ADMINISTRATIVE AMENDMENT TO PUD 129 - AMENDMENT No. 2

THAT, Planned Unit Development No. O-2021-159 (“the Plan”) was adopted by the City Council of the City of Round Rock on June 10, 2021, recorded in Williamson County, Texas as 2021087666; and

THEREFORE, we hereby delete **Part II, Development Standards** in its entirety and replace it with a new **Part II, Development Standards**; and we hereby delete **Exhibit ‘B’, Concept Plan** and replace it with a new **Exhibit ‘B’, Concept Plan**:

EXHIBIT 'B'

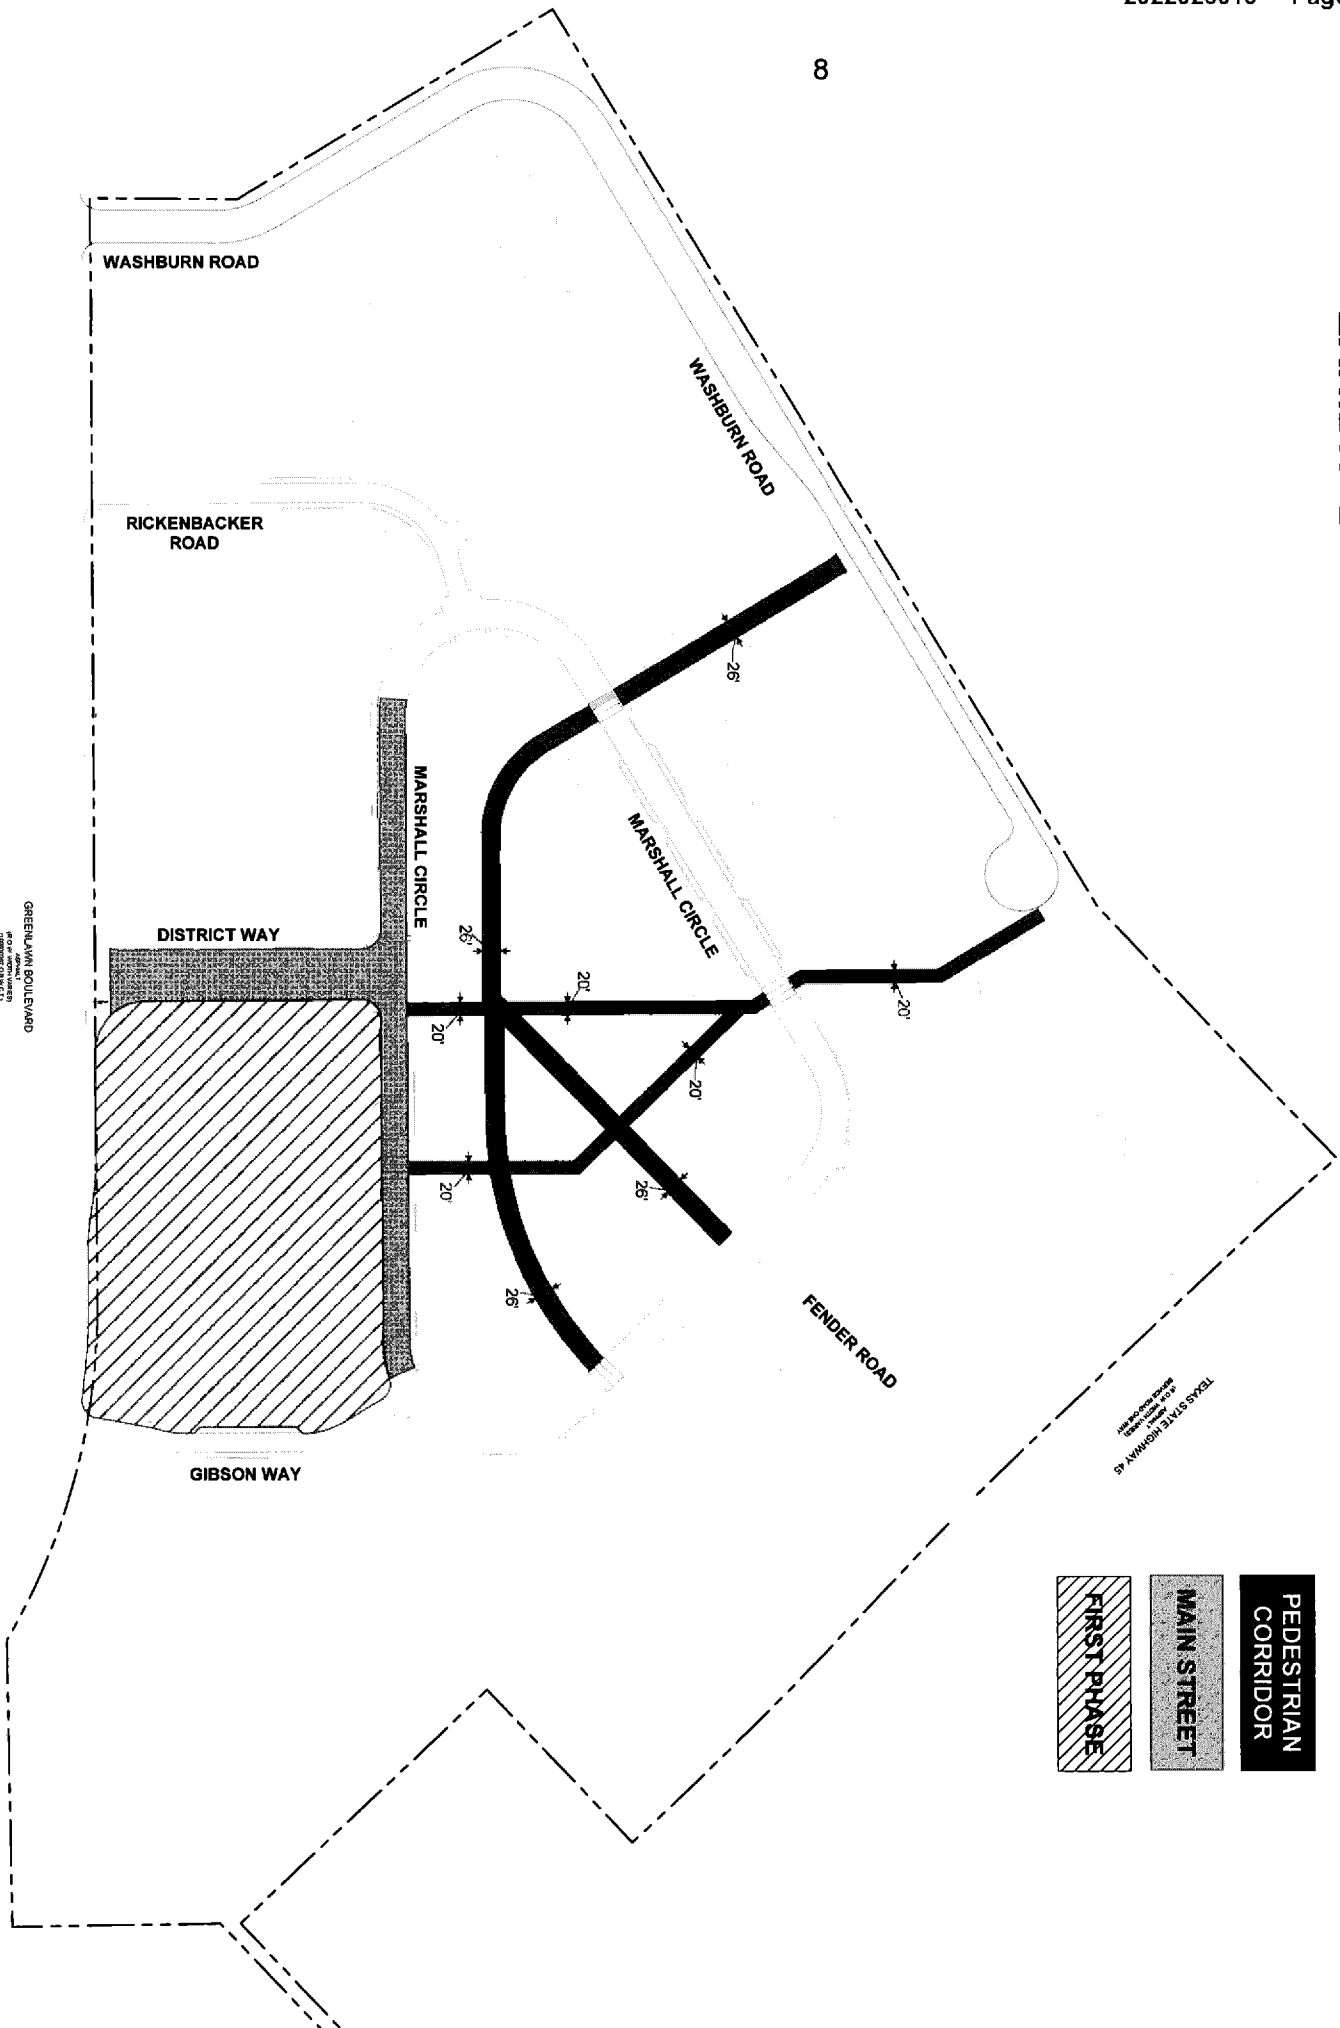
THAT, we have modified **Exhibit ‘B’, Concept Plan**.

- a) Section 2-75(c)(1)(d)(1) shall be replaced with: All proposed projects shall have a main street which serves as the core of the project and is designed in accordance with the "Walkable Thoroughfares" standards in the table in subsection 7.2 below.
- b) One cul-de-sac road indicated as ‘Washburn Road’ on **Exhibit “B”** is permitted.
- c) The location of internal driveways are reflected in **Exhibit “B”**.
